RESOLUTION NO. 16-220

Subject: **Approve use of Unforeseen Conditions Allowance and Contingency Allowance for construction of Phase IA of the Truman Waterfront Park**

PROJECT: Truman Waterfront Park Phase IA

FIELD CHANGE DIRECTIVE
No. 03

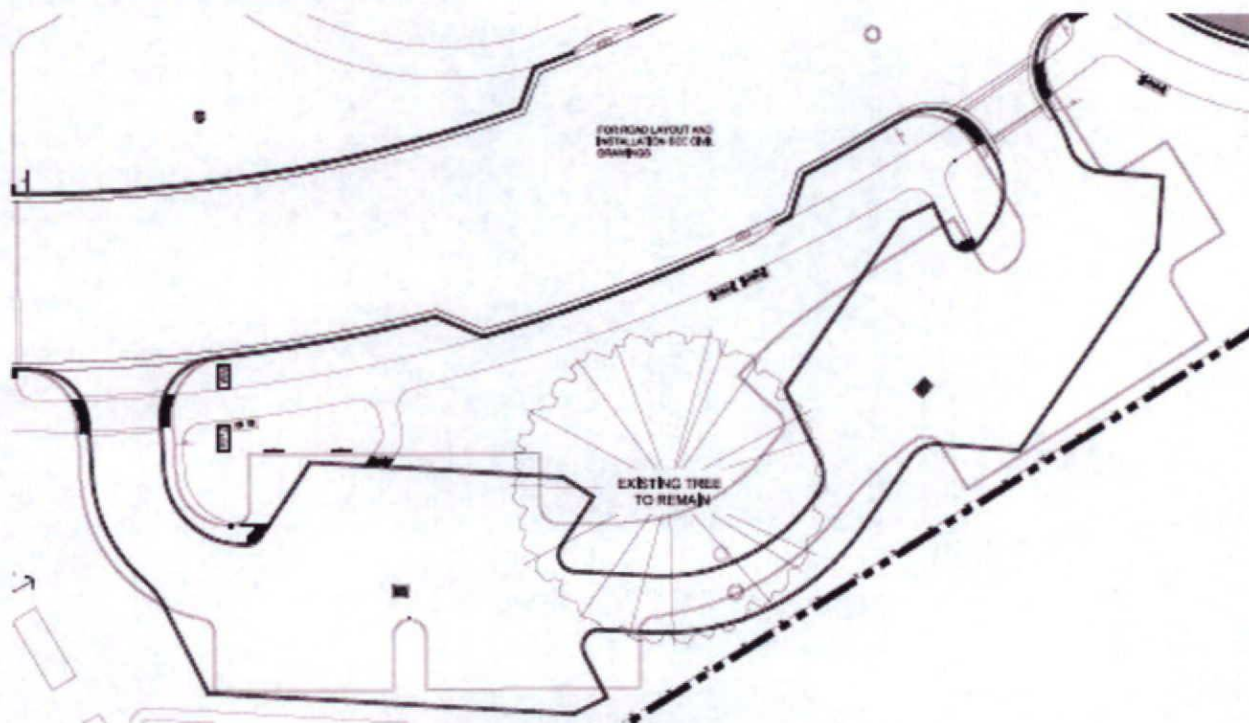
The Delta 3 drawing revisions generally consist of reconfiguring the parking near the existing Seagrape tree (described as Tree No. 38 on LT-05 and LT-06) along the east side of the property from square spaces with two-way traffic (the lighter edge of pavement below) to angled spaces with one-way traffic (the darker edge of pavement lines below). The diagram below shows the general shift of the road alignment from the bidding documents, shown in light gray lines to the current design, shown with black lines:

This change consists of a parking lot reconfiguration and lies to the east of and is adjacent to the section of the southerly spine road between stations 21+00 and 24+00. This change also incorporates a modification of the exfiltration trench system near Ficus #41 located to the Southwest of the Southard Street roundabout at the main entrance to the park. While every effort has been made to create a summary of all of the changes made during this revision, the contractor shall examine the plans and note any additional changes.

1. New alignment of access road that provides the baseline for reconfigured parking stalls.
2. Locations of modified entrance/exit to the said access road for reconfigured parking lot.

3. Said access road was modified to be a one-way road with 60-degree parking stalls as opposed to the previous design of a two-way road with 90-degree parking stalls.

8. Retention Area E was reconfigured to accommodate changes to said parking lot. See Sheet CP-05.
9. Pavement markings in the previously described area have been moved to align with the modified roadway and should be examined by referencing sheets CM-03 & CM-05.

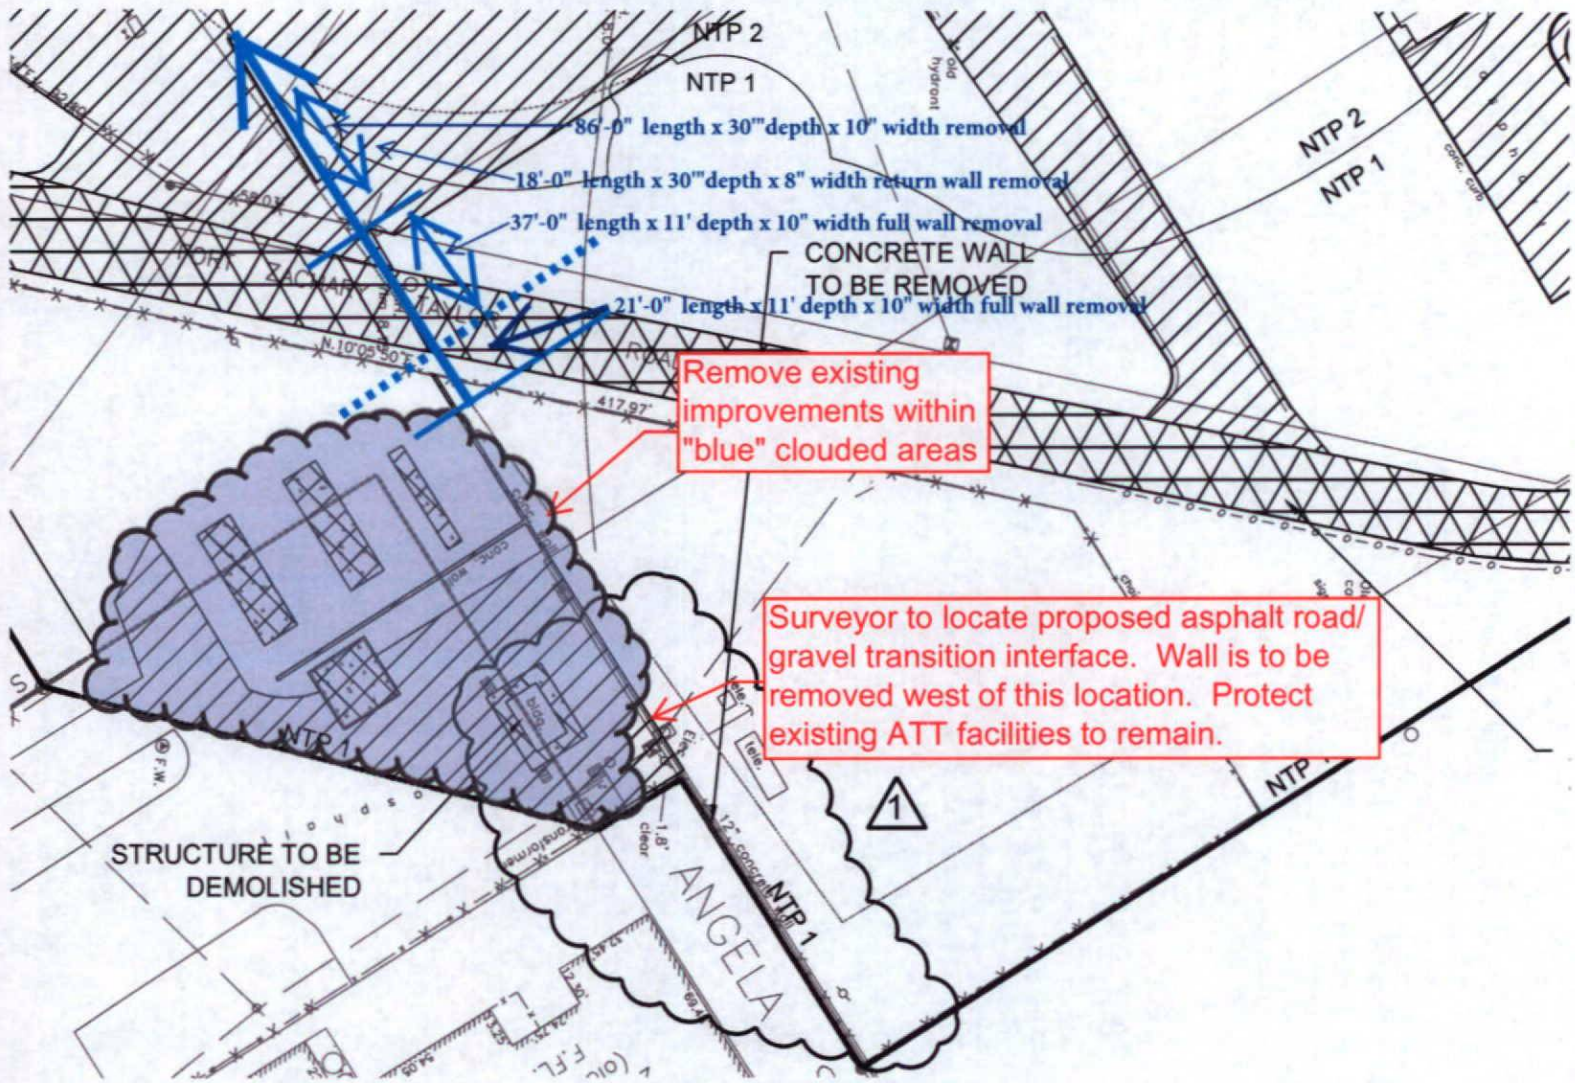
Demo of the concrete retaining wall from 14'-0" from property line per RFI 023 revealed the concrete wall was 6'-9" below grade, greater than 4'-5' typical for retaining wall condition. The wall continued beyond location where wall visibly terminated to into the ground: 21' length x 11' depth x 10" [not included in this CO].

Additional demo requested for Unforseen Seawall Condition:

86' length x 2'-6" depth x 10" partial wall removal only

18' length x 2' -6" depth x 8" partial wall removal only

37' length x 10' depth x 10" width full wall removal

While acknowledging that the demolition drawings could have been clearer as to the Engineer's intent and that the depth of the wall was unknown, the horizontal extent of the "conc. wall" was shown on the survey drawings and visible for inspection/questions during the bid phase. As such I propose that the City will cover 3/4 of the cost (\$11,313) of wall removal/disposal, with CTS absorbing the remaining 1/4 (\$3,771) under the NTP1 Base Bid. The City's cost will be paid under the Unforeseen Conditions bid item.

SK-003 - Coordination - Subgrade Work Plan

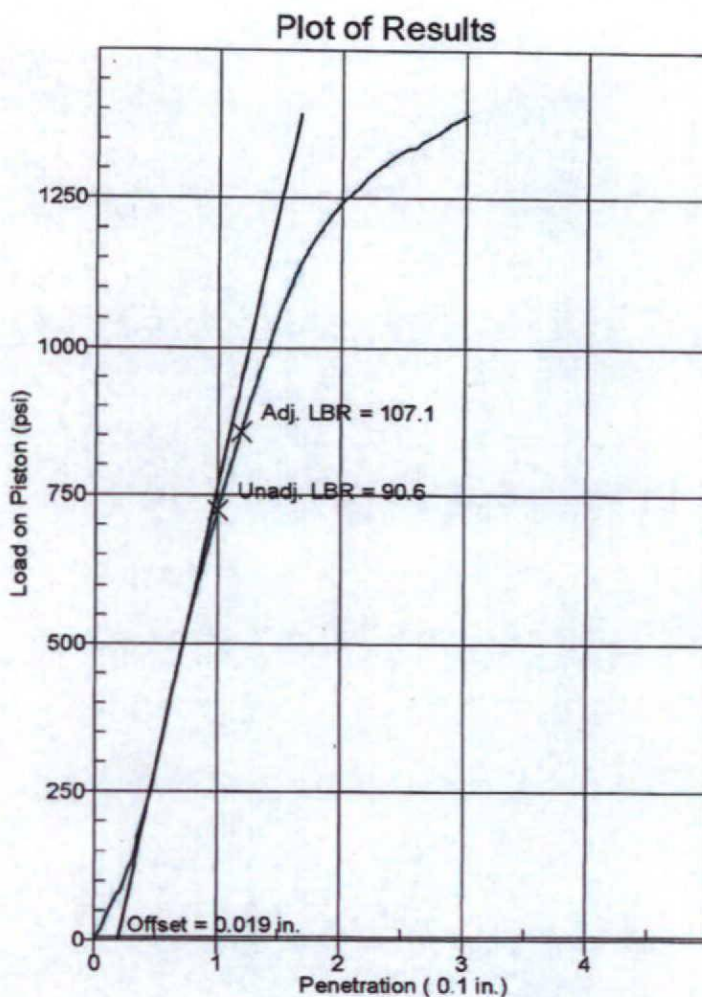
During the visit and Subgrade discussion last Monday, 23 May 2016, we agreed to proceed with LBR testing of the "Superblend" material. The result = unadjusted 90.6, please see the attached.

It was the professional opinion of the Soils Testing technicians with Concrete Analysis & Testing Laboratories, Inc. that the existing materials from the Fort Zachary entrance area to SSMH 1 were not suitable to achieve LBR40 through mixing based on previous site sampling and testing data results. To mix with the existing materials on site would risk inconsistent results and potential settling over time.

This proposal is for the removal / replacement of the 12" subbase with a suitable material as referred to in our discussions and per the Nutting Report, page 9, paragraph, Paving Areas. The attached sketch illustrates the quantity of materials and specific area of impact at this time.

As a follow-up to our meeting today, the City Engineering staff agrees with Toppino's recommendation to replace existing unsuitable subgrade material with imported "Superblend" aggregate placed full-depth (12 inches) within the spline roadway. Placement limits extend from the Navy Pedestrian Bridge to approximately Station 11+00 (Drawing CG-05). Full depth placement was recommended to achieve the necessary load bearing factor (LBR) for long term stability of the roadway, including access to the Navy Port Operations and Ft. Zachary State Park. The proposed costs to implement this recommendation is \$95,594 (see attached). As agreed, the City will reimburse Toppino the cost of replacement material (1,530 tons @\$30.50 per = \$46,665.) plus 50% of unsuitable subbase excavation cost (\$10,307.), totaling \$56,972. Payment will be made under SOV Item 39, Unforeseen Conditions Allowance. Please provide Superblend delivery weight slips to Terry on a daily basis to verify material quantities delivered to the site.
